1435 - P045a

Entrance Hall//Existing//Plan_1:20

1435 - P070

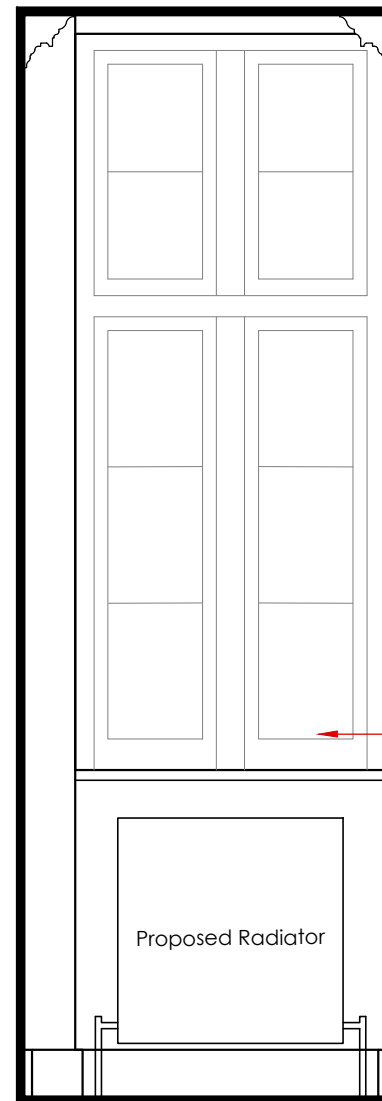
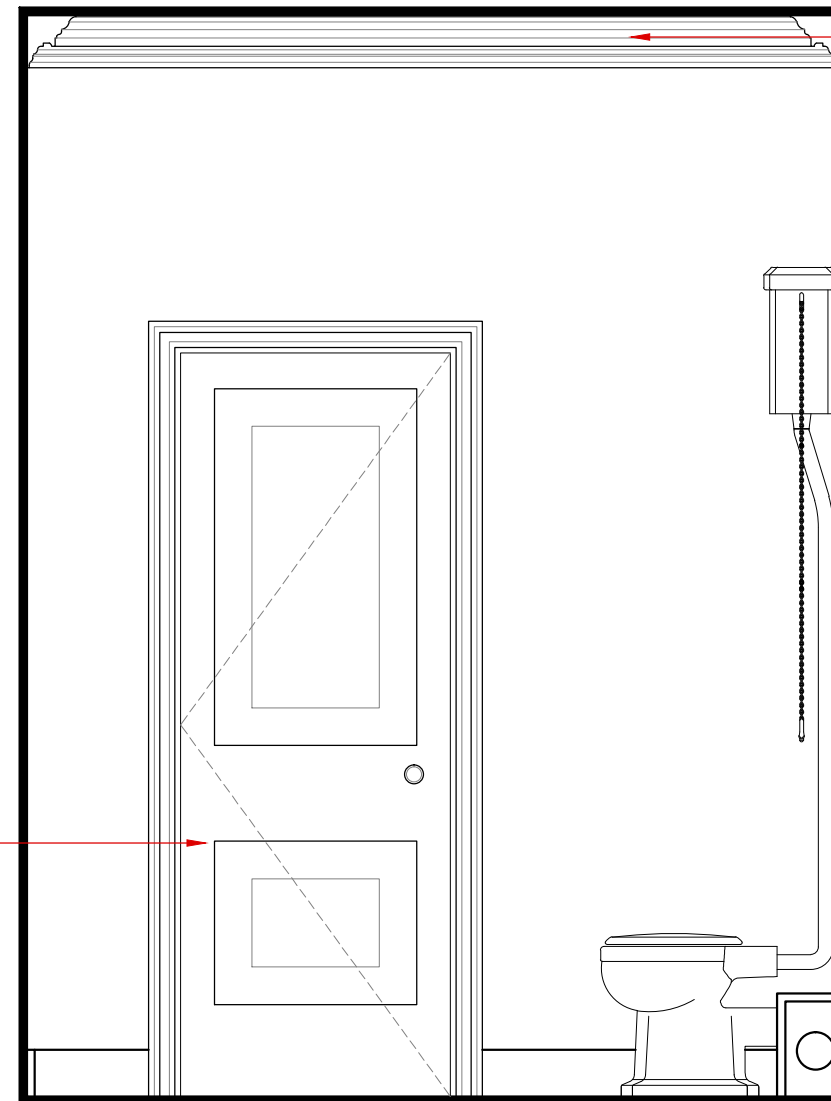
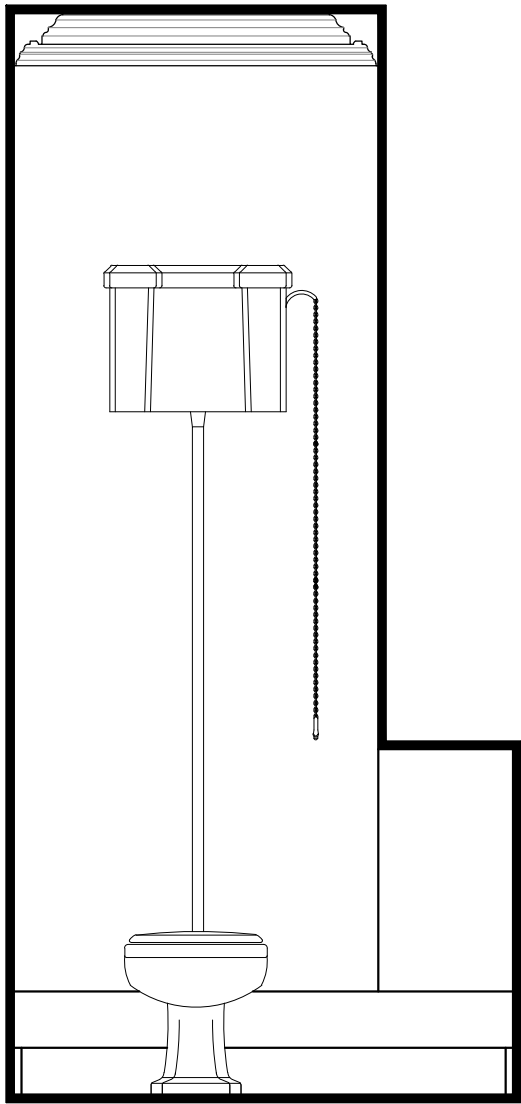
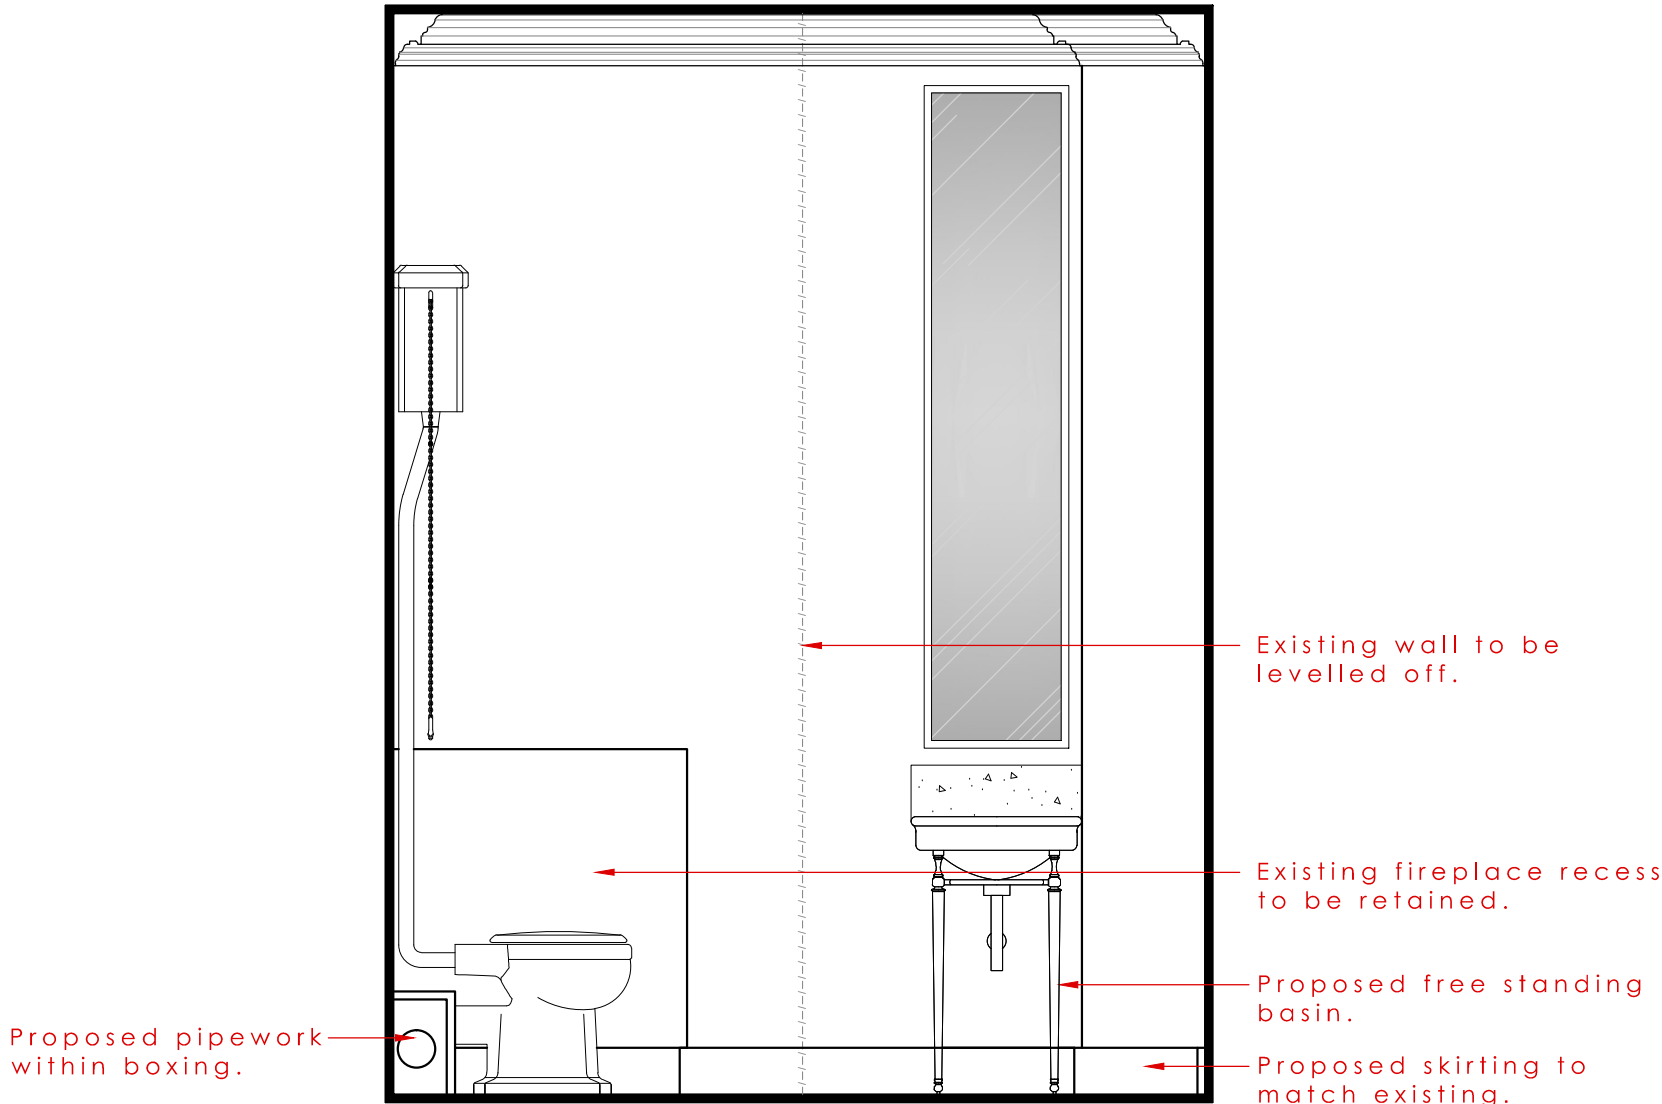
Rev	Date	Notes
A	14.05.15	Existing fireplace opening retained following comments from council.

Existing secondary
glazing removed.

Proposed 2 panel door
to match D.G.06.

Proposed cornice to
match existing with
Drawing Room.

Rev	Date	Notes
A	23.06.15	Radiator added.

Rev	Date	Notes
A	14.05.15	Existing fireplace opening retained following comments from council.
B	23.06.15	Sanitaryware revised.
